AGENDA PORTLAND PLANNING BOARD MEETING

Memorandum Planning and Urban Development Department Planning Division

To: Sean Dundon, Chair and Members of the Portland Planning Board
From: Andrew Tufts, Planner
Date: September 20, 2019
Re: Redevelopment, 33 Montreal Street, 33 Montreal, LLC
Project #: PL-000807-2019 CBL: 015 B022
Meeting: September 24, 2019

CONSTRUCTION MANAGEMENT PLAN

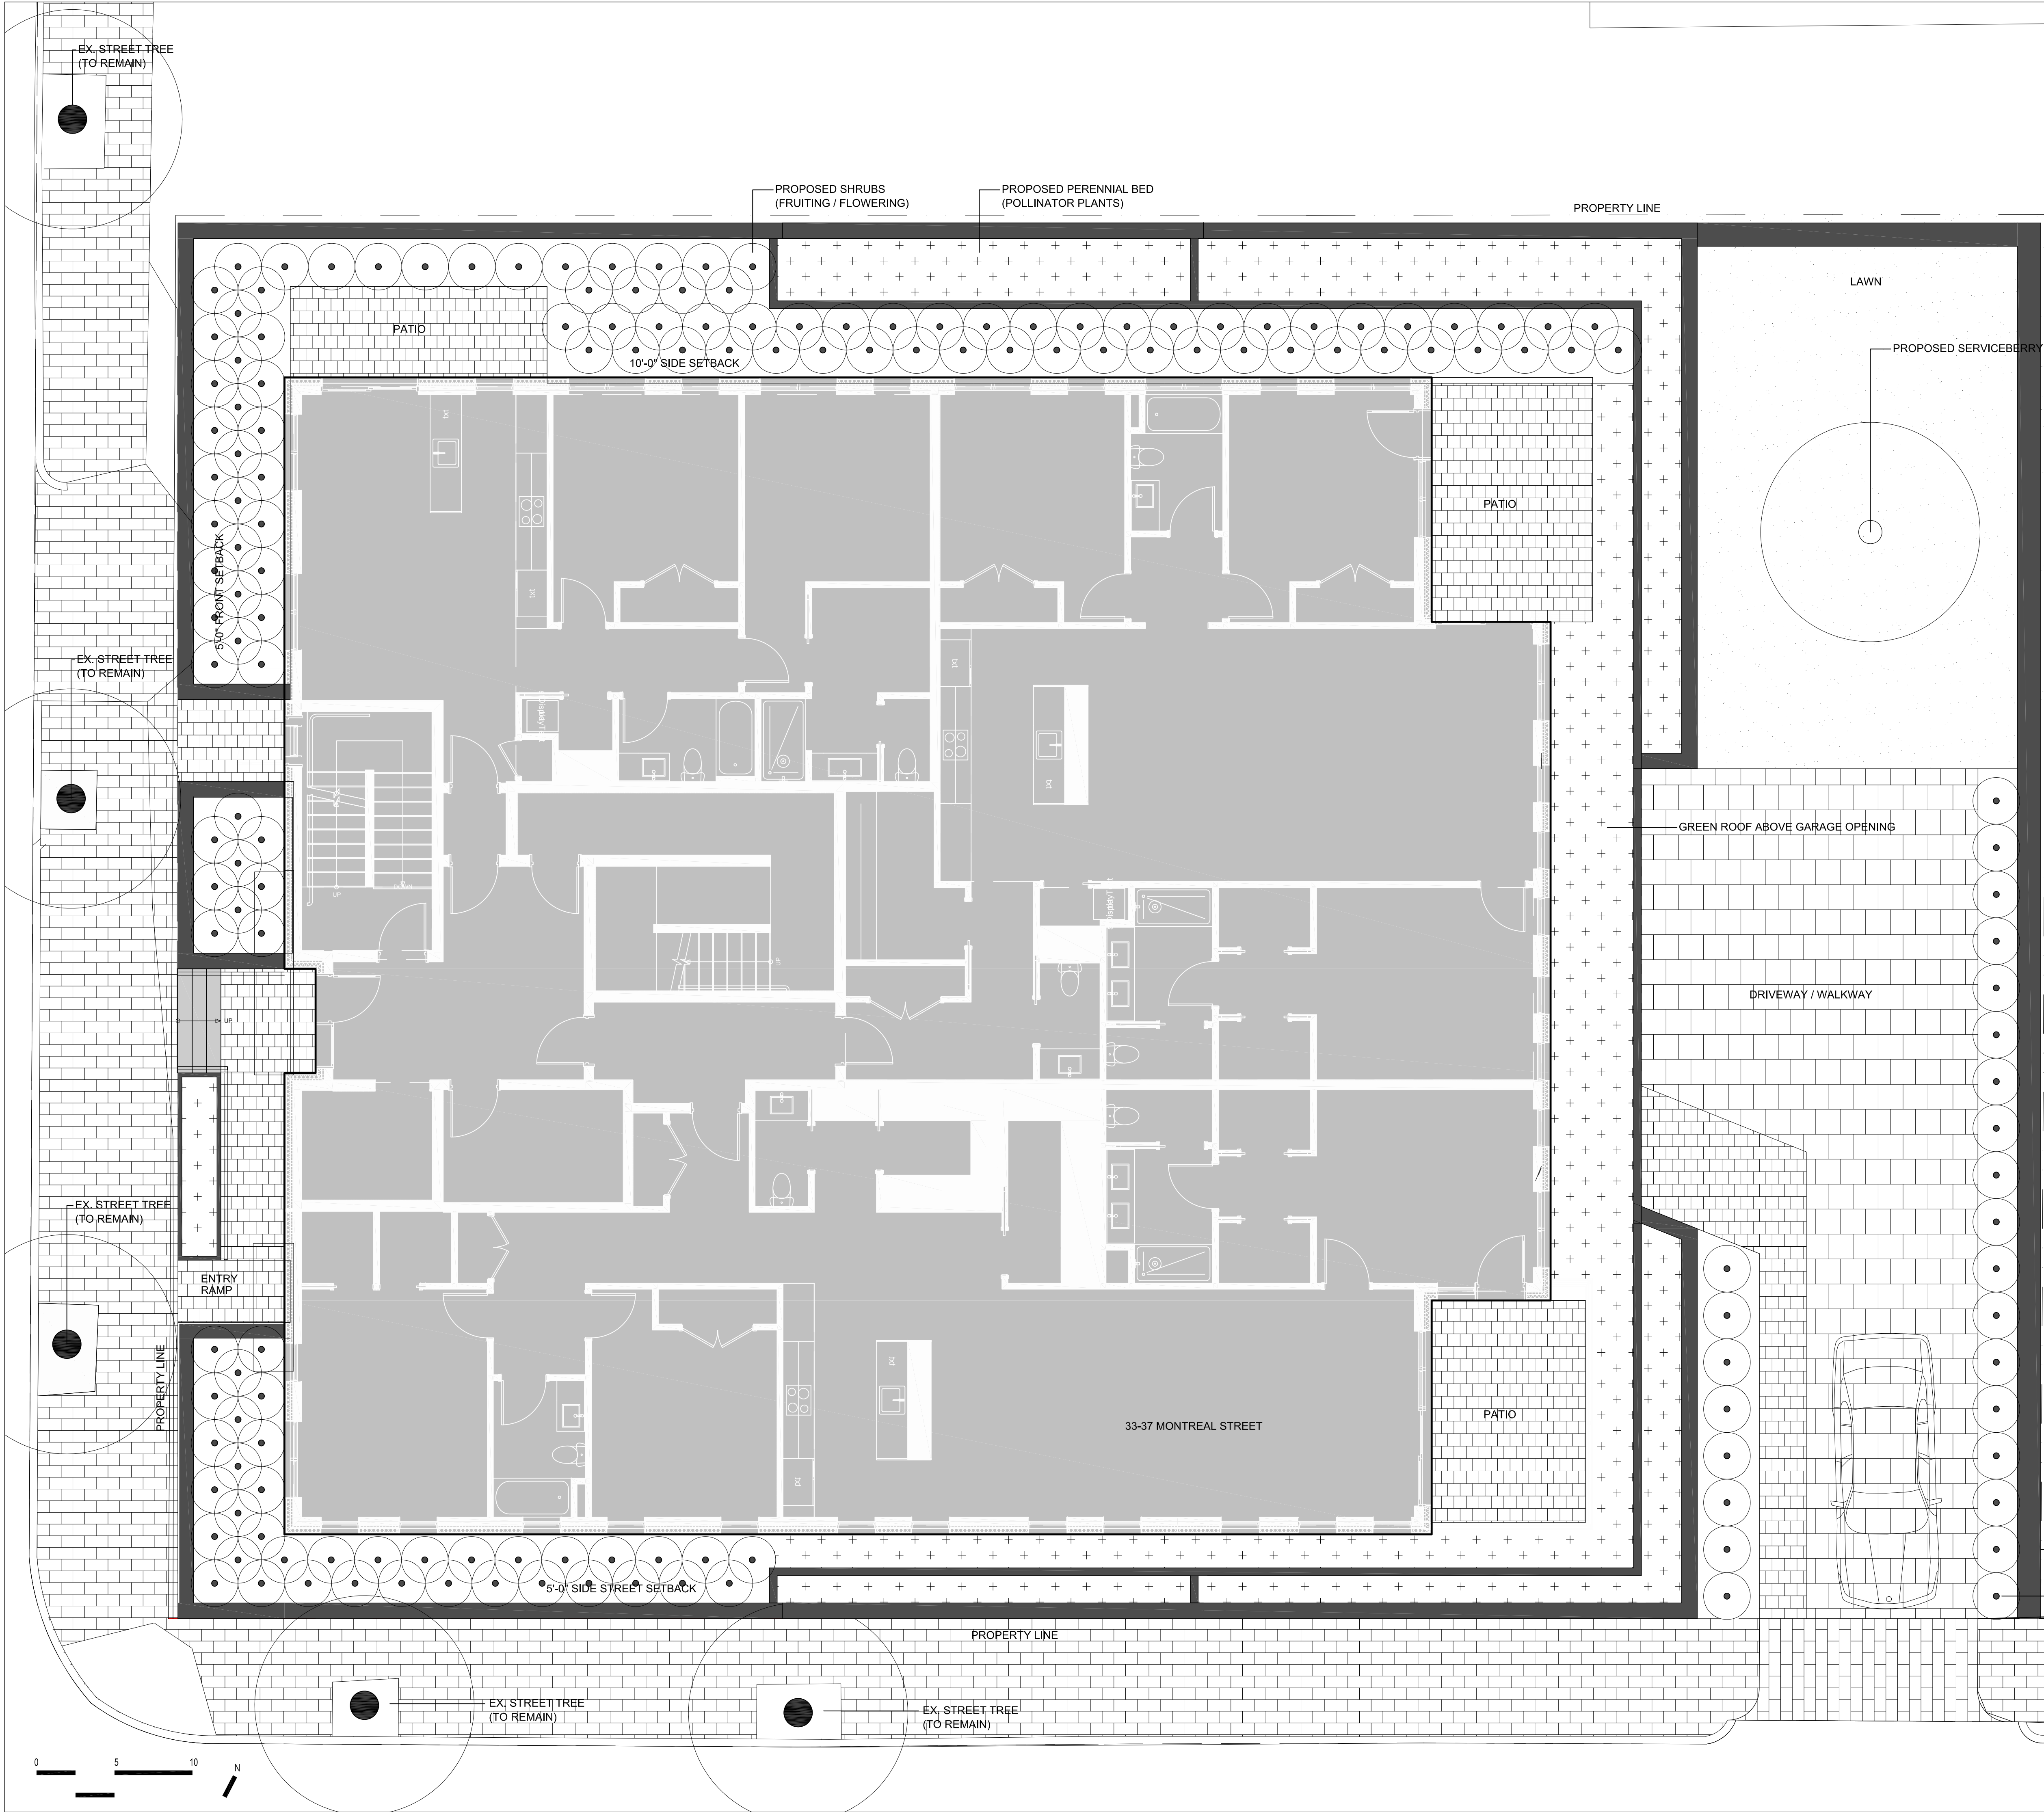
- It is noted that on the construction management plan drawings, a dumpster is proposed on a steeply sloped area at the northern corner of the site. This should be reviewed, and if

- A serviceberry tree is proposed on the northern corner of the site over the end of the proposed subsurface chambers and overlapping the area identified on the plans as snow storage.
